WAGON USERS Study Group

Proposed amendment to GCU Appendix 10

Title:	5.13 – Screw coupler
Proposed amendment made by: RU / keeper / other body	SNCF
Proposed amendment concerns:	<input checked="" type="checkbox"/> Appendix 10
Proposer:	Geoffroy MAILLE
Location, date:	01/03/2016
Concise description:	Define limit value for play between chain link and screw.

2.1. Elimination of anomaly/problem (goal)

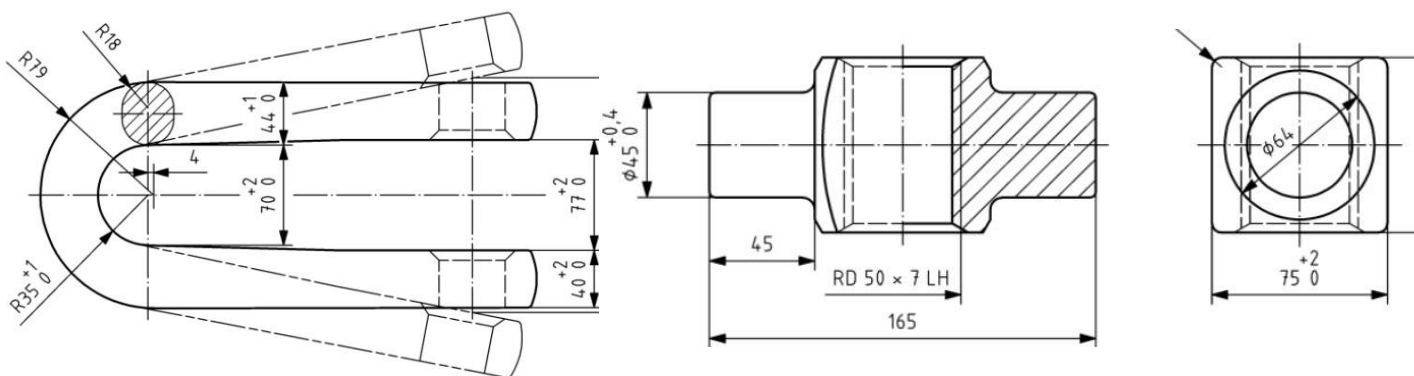
Appendix 10 defines no limit value for the play between the screw and the chain link on screw couplings. However, numerous RUs have defined internal rules. Since some of these rules differ, this creates problems of understanding during wagon overhaul.

The repeated loads to which it is subjected may cause the link to shift from its original position, causing play between itself and the screw. Since this may represent a risk, a maximum value for such play needs to be defined.

The lack of a limit value for play has prompted RUs to introduce their own rules, which differ from one company to another. Practice should be harmonised.

The manufacturing diagram indicates that the maximum play possible on a new coupling is: Maximum dimension of chain link (79) – Minimum dimension of screw (75) = 4 mm

In new condition, therefore, the maximum play is 4 mm.

From experience, when SNCF had its screw couplers repaired (simplified examination), it recommended tightening the chain link such as to obtain a functional play of less than 5 mm if the play measured during preventive maintenance was between 8 and 35 mm. The 8 mm limit value comes from Level 4 maintenance – logically enough, since a more restrictive dimension is needed than for corrective maintenance, where 10 mm is recommended.

Check play between chain link and screw. Play must be less than 10 mm.

5.13 The screw couplers and draw hooks must not be missing. Any clearance between the chain link and the screw must be less than 10 mm.
